MUNICIPALITY OF ANCHORAGE

PLANNING AND ZONING COMMISSION RESOLUTION NO. 2009-047

A RESOLUTION RECOMMENDING APPROVAL OF THE HILLSIDE DISTRICT PLAN AS AN ELEMENT OF THE ANCHORAGE BOWL COMPREHENSIVE PLAN.

**ATTACHMENT A
PLANNING AND ZONING COMMISSION RESOLUTION NO. 2009-047**

28. Page 2-28 Map 2.10 (Issue LU-6) Modify Map 2.10 and associated text to be consistent with the above language and intent as shown in the table below, i.e., change 2 dua with an 8-acre parcel or 3 dua with 12-acre parcel and change 10 to 12 acres.

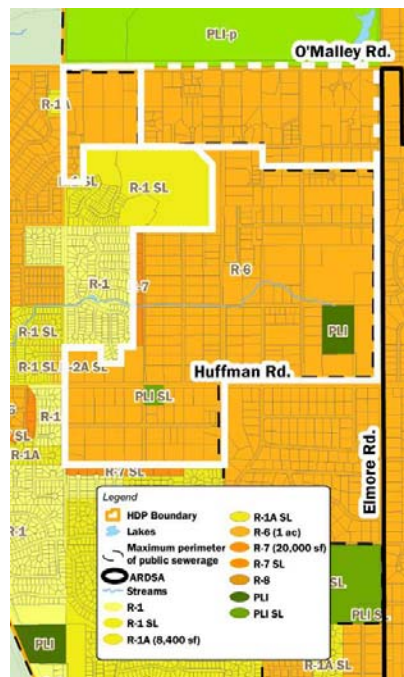
Remove highlight of BLM lots and remove the following language: ~~Possible area for future increased residential density; expected to be re-examined when the Hillside District Plan is updated.~~

Change map in Furrow Creek area to reflect the modified boundary below:
